"A PLANNED UNIT DEVELOPMENT"
P.U.D./P.O.A.D.P. PLAN

for
O'CONNOR GVH SUBDIVISION

POADP # 691

SUBJECT: O'connor GVH, POADP / PUD Level 1 T.I.A.

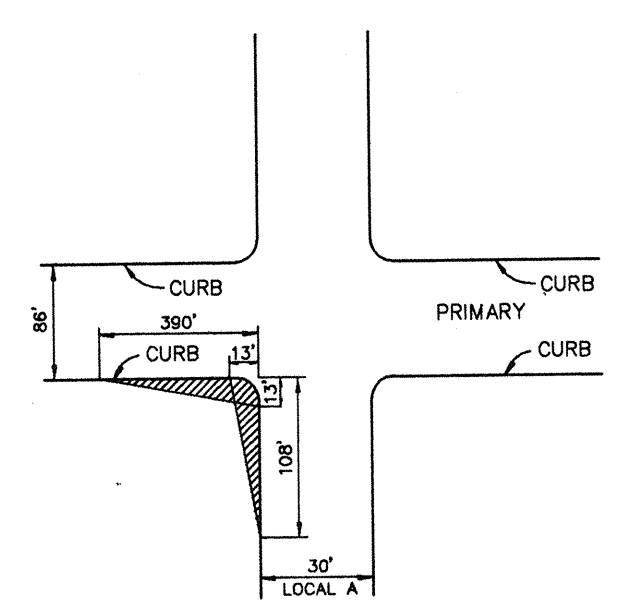
Comments: Relocate Pinchurst Row (Entrance to Subdivision
on Knollcreek) closer to Corian Park.

Due to the proximity of O'connor Rd. with the Knollcreek access, the Traffic Division recommends moving the Knollcreek access at least mid-way between Knollcreek and Corian Creek.

The entrance off Knollcreek cannot line up with Corian Creek Drive because the corresponding grade would be higher than the maximum allowable grade, for a local road, of 10%. The change in the existing elevation is approximately 22 feet in 145 feet (15.2 %) which would require a variance to the rule or the new street to be dug in 8 feet.
